ALUM ROCK
UNION ELEMENTARY SCHOOL DISTRICT

ADDENDUM #1 FOR
RFP No. 2425-Bonds07
Bid Package 3

Exterior Painting
Lyndale Elementary School
Russo/McEntee Academy

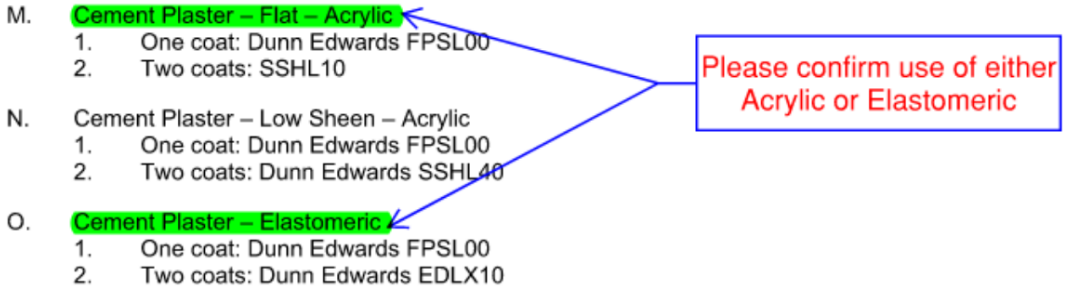
1. Q:

Multiple coating systems have been specified for a single substrate. To ensure accurate material pricing, we respectfully request clarification regarding the intended system to be utilized.

A: Proceed with **Velvet**-Acrylic Paint in lieu of Flat Acrylic for cement plaster and concrete block surfaces.
